5-VALVE
S.M.O.
1940

BULLETIN NO. 141 *Sept 1940*

5-VALVE BROADCAST PACEMAKER
RECEIVER.

5V PACEMAKER RECEIVER MODEL 5110

SCHEMATIC DIAGRAM

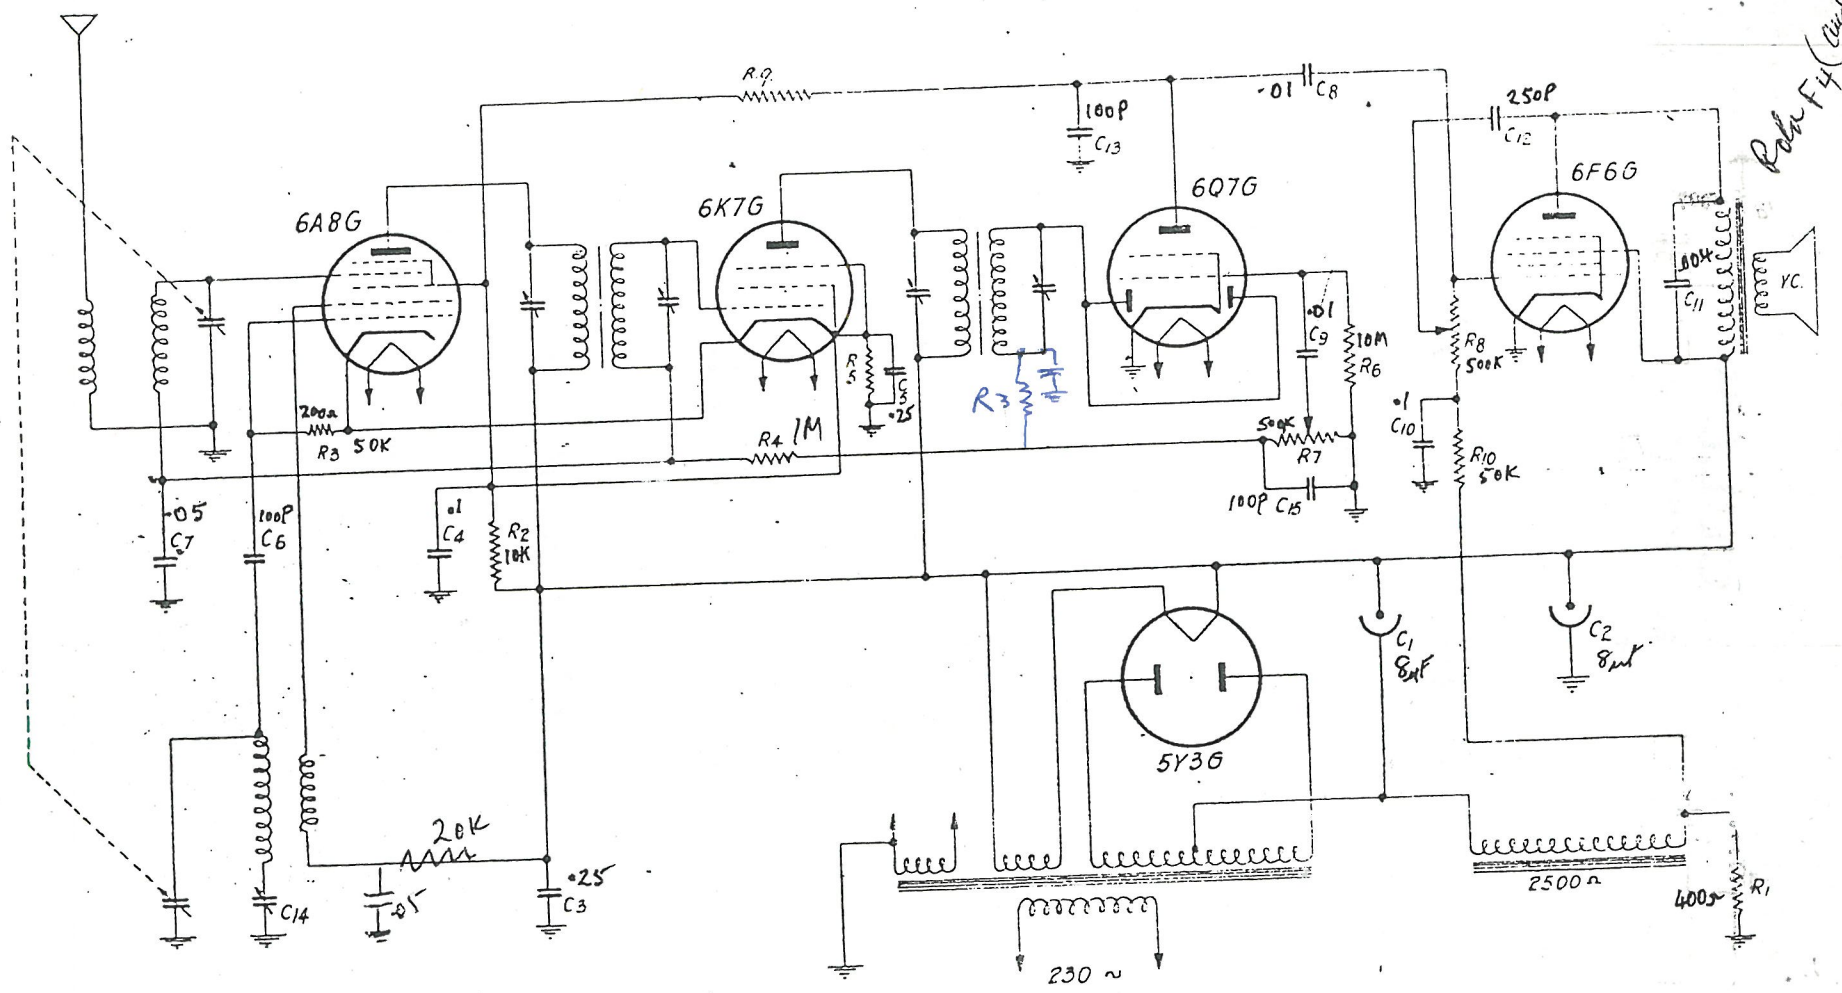
*Note error in drawing
diode filter res. + cap omitted,
R3*

Plate F4 (Construction?)

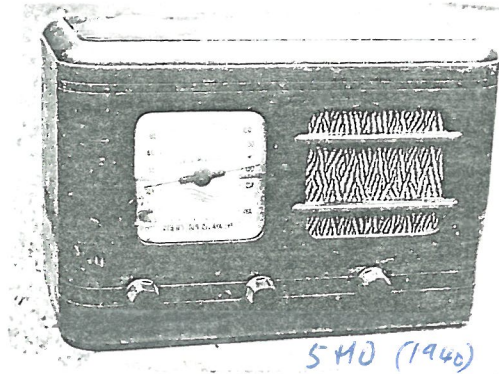
Mod: reduce excessive output voltage
